**IMPORTANT SAFETY RECALL**

**SUBJECT: SAFETY RECALL: DRIVESHAFT CONTAINMENT**

Ref.: **NHTSA # 14V-335**

# Service Bulletin No. 414

**Figure 1.**

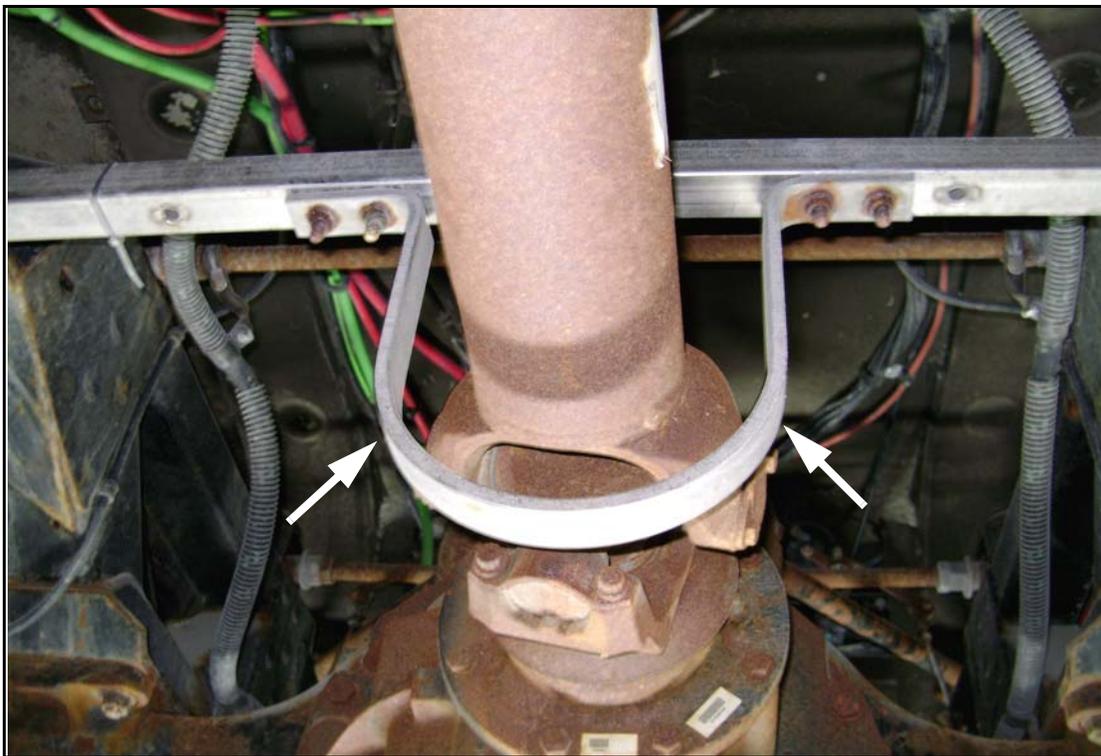
1. Turn the main battery disconnect switch to the OFF position.
2. Using wheel lifts, lift the coach to the desired work height.
3. Position jack stand supports under the coach frame support points.
4. Locate the driveshaft, installed between the transmission and the drive axle ( refer to Figure 1 ).
5. Remove and retain the mounting hardware on the driveshaft guard ( refer to arrows in Figure 1 ). Remove and retain the driveshaft guard to be re-installed at a later step in this procedure.

23. Using the existing mounting hardware, re-install the driveshaft guard ( refer to arrows in Figure 1 ). Torque hex nut to 15-25 ft-lbs. Tighten jam nut to secure.

Figure 4.

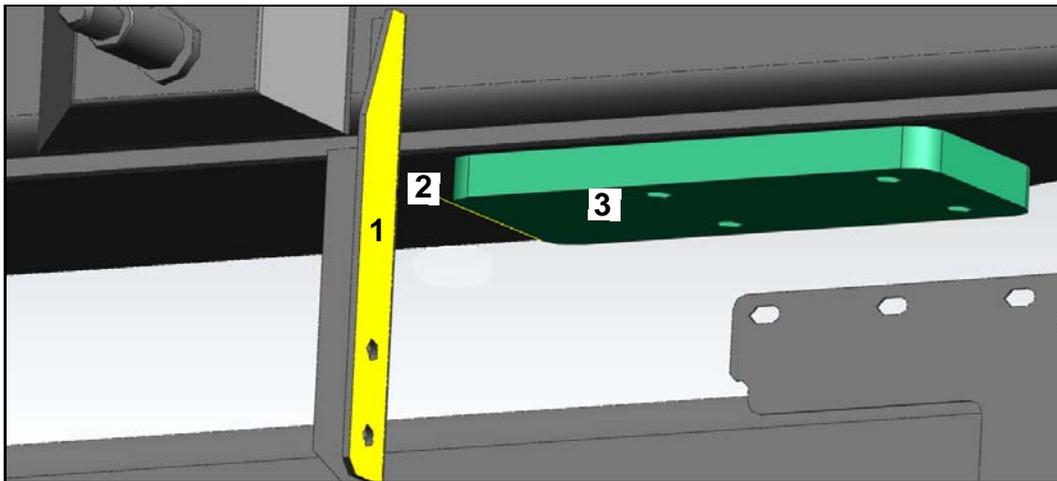
8. Locate the bracket, shown as Item 1 in Figures 3 and 4, positioned approximately one ( 1 ) foot away from the crossmember assembly that the driveshaft guard ( Figure 1 ) was mounted to. The vertical face of this bracket will be the reference point utilized to position the tapped plates in Figure 7.

**Figure 5. Protection valve ( gladhands equipped ).**

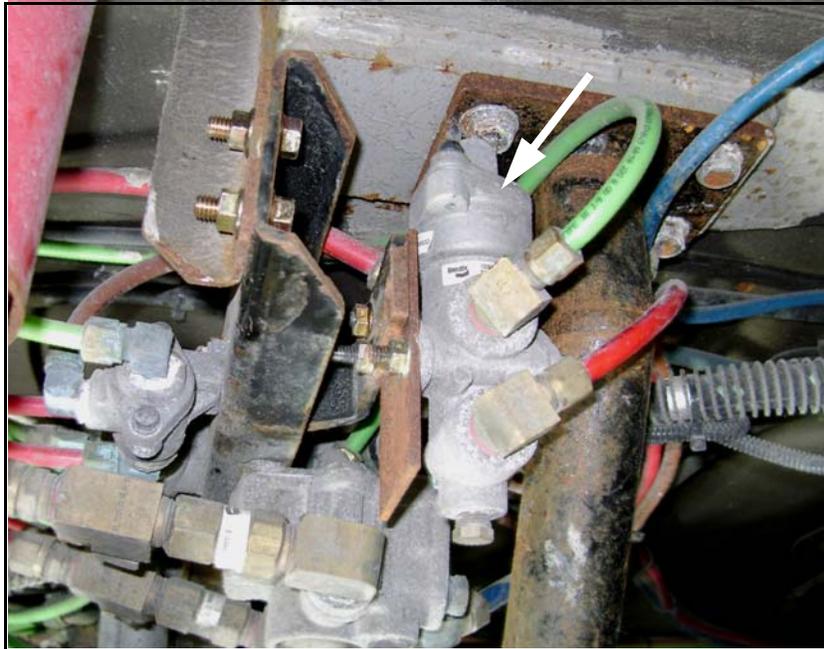
9. Locate and remove the protection valve ( refer to Figure 5 ).

Figure 6.

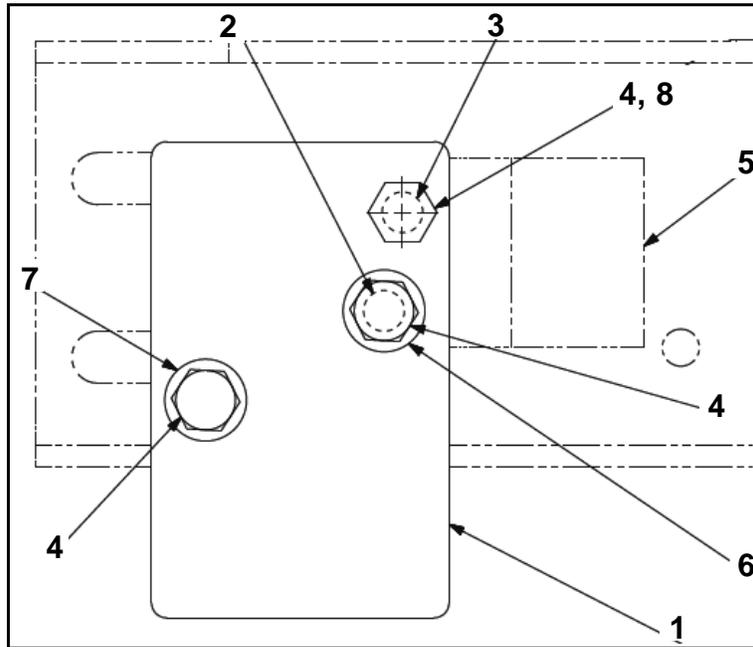
10. Align the indicated hole ( Item 3 in Figure 6 ) in plate, p/n 03-33-2834, with the existing hole in the welded bracket. Secure with hardware.
11. Using a 0.343 drill bit and the plate as a template, drill a hole through the welded bracket ( Item 2 in Figure 6 ).
12. Re-install the protection valve using the hardware provided in the Parts list. Re-orient fitting and airlines and secure with a tyrap, p/n 19-11-258.

**Figure 7. Plate installation.**

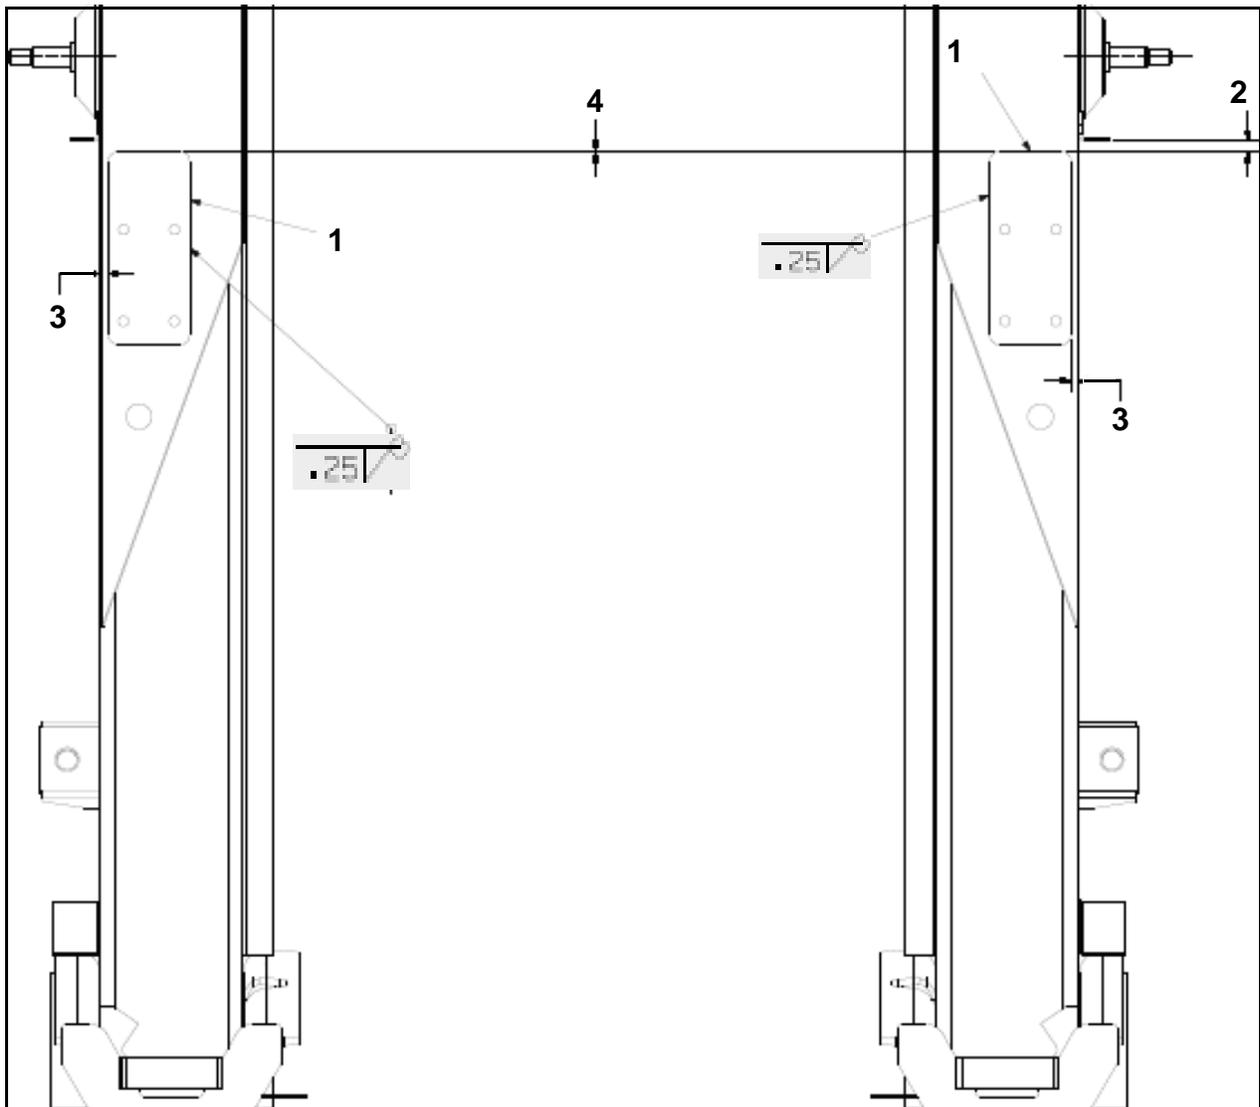
13. Position the tapped plate, p/n 03-56-1642, on the bogie structure as outlined in Figures 7 and 8. Mark a chalk outline around the entire plate. Remove plate. Repeat step to opposite side of the coach.
14. Using a wire brush, thoroughly clean the surface area of dirt and grease from the location(s) where the tapped plate(s) will be welded.

***Ensure full surface contact between the tapped plate and the bogie structure.***

15. Tack weld the tapped plate on both sides of the coach. Orient the driveshaft hoop assembly, p/n 03-33-2711, with the holes in the tapped plates to ensure correct installation. Place the driveshaft hoop assembly aside to be re-installed at a later step in this procedure.
16. Weld the plate according to the welding symbol in Figure 7, using the following method,
  1. SHIELDED METAL ARC WELDING ( SMAW )
    - a. 1/8 rod - 7018, 100A-115A
  - or,
  2. GAS METAL ARC WELDING ( GMAW )
    - a. 0.045 diameter - 70S3, 25V-26V or 300-320 1PM
17. Repeat Step 16 to opposite side of coach.

**Figure 8. Hoop assembly installation.**

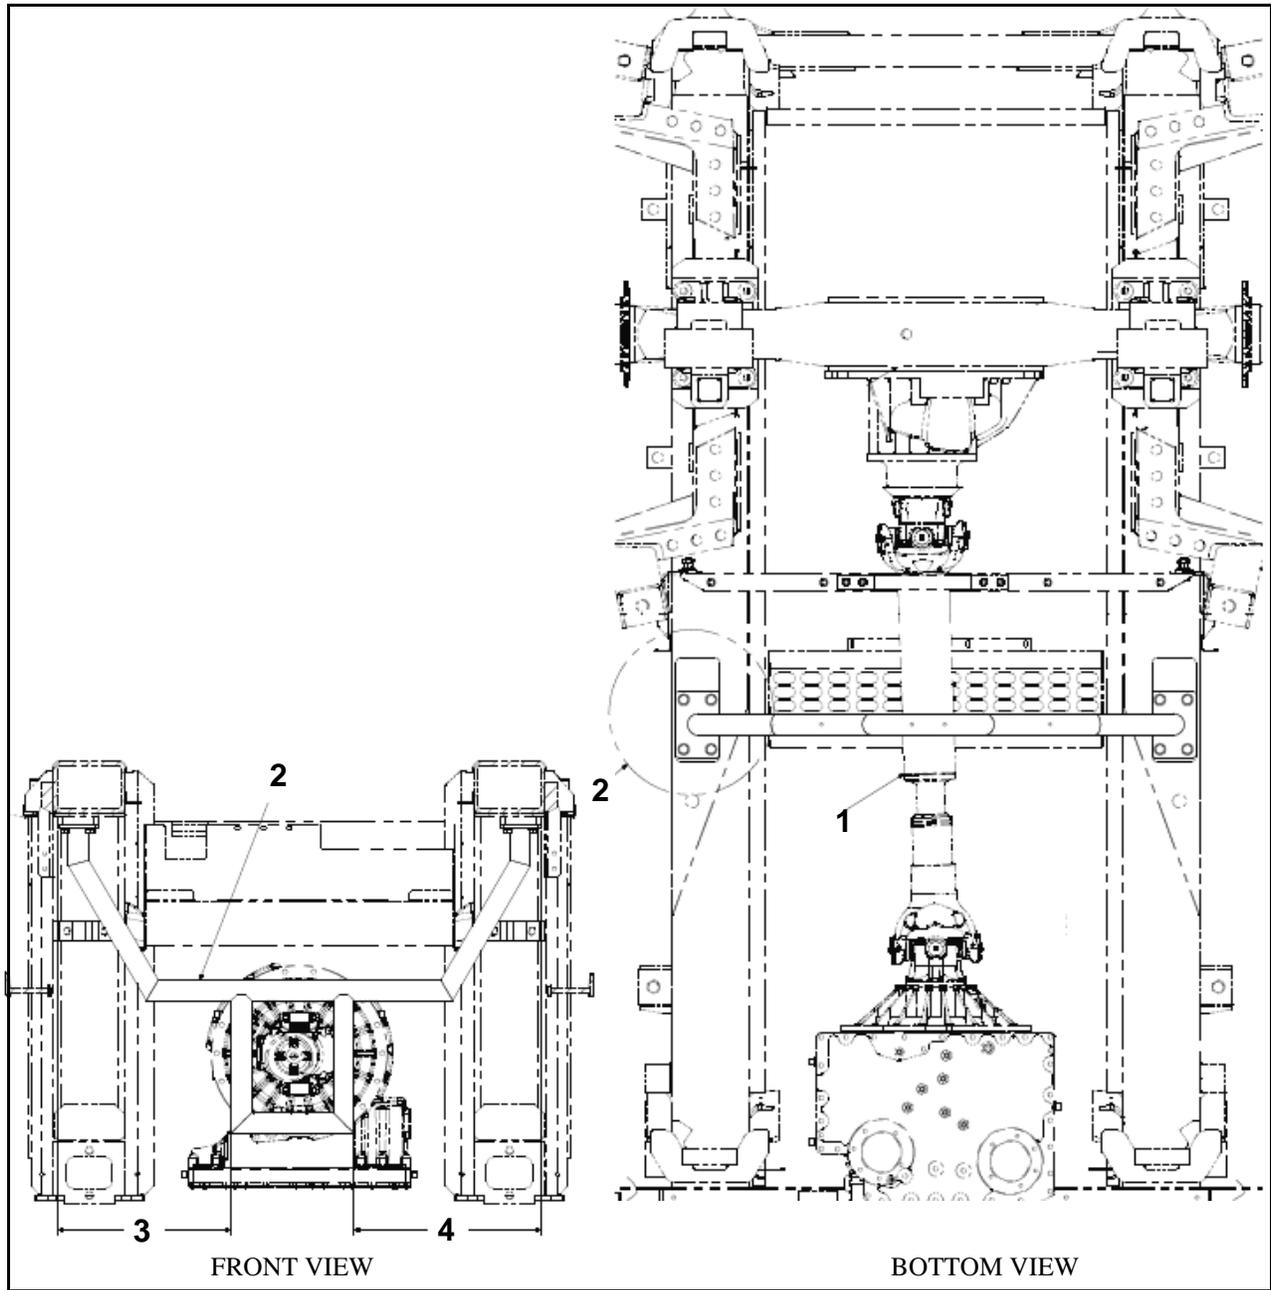
18. Orient the driveshaft hoop assembly, p/n 03-33-2711, as shown per the views and dimensions provided in Figure 8.
19. Apply Never Seez to the threads of the capscrews, p/n 19-01-1535. Using the capscrews, secure the hoop assembly to the tapped plates welded in Step 16. Torque capscrews to 75-80 ft-lbs.

**Figure 9. Driveshaft hoop assembly installation.**

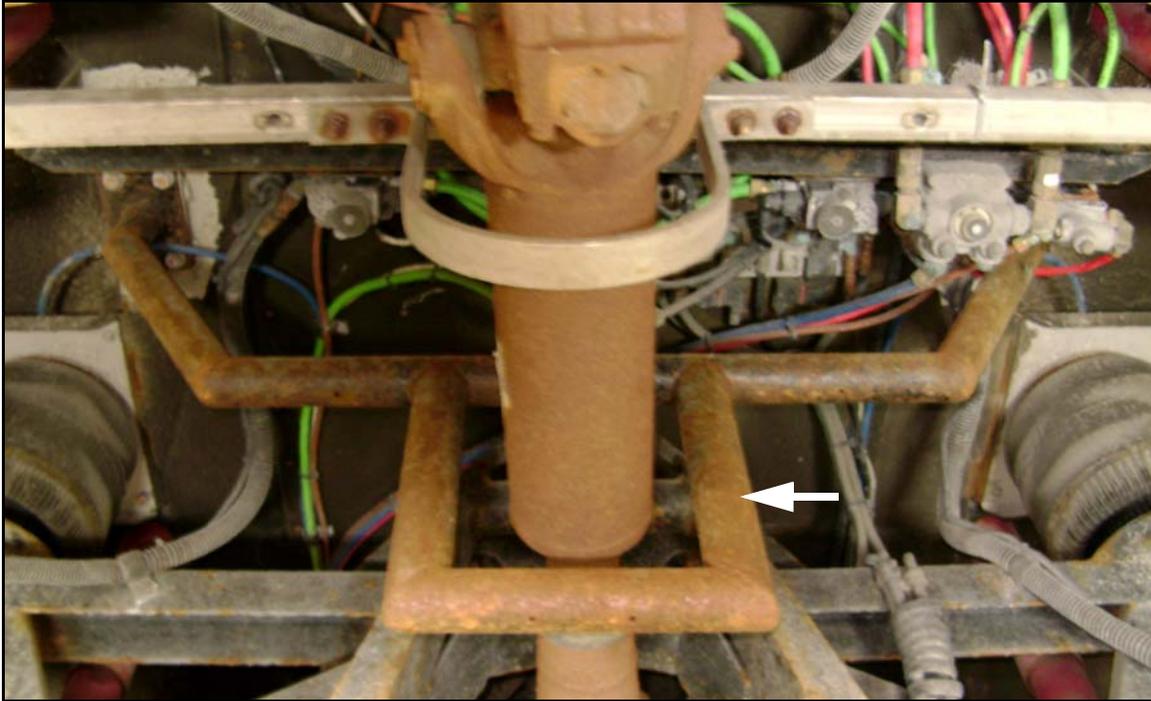
20. Orient the driveshaft per the labeling earlier in this procedure. Insert the driveshaft through the lower opening of the hoop assembly as shown in Figure 9. Using two ( 2 ) strap / bolt kits, p/n 14-01-1028, attach the driveshaft to the yoke flange on the transmission ( refer to Figure 10 ). Torque to 115-125 ft-lbs.
21. Using two ( 2 ) strap / bolt kits, p/n 14-01-1028, attach the opposite end of the driveshaft to the yoke flange on the drive axle ( refer to Figure 10 ). Torque to 115-125 ft-lbs.
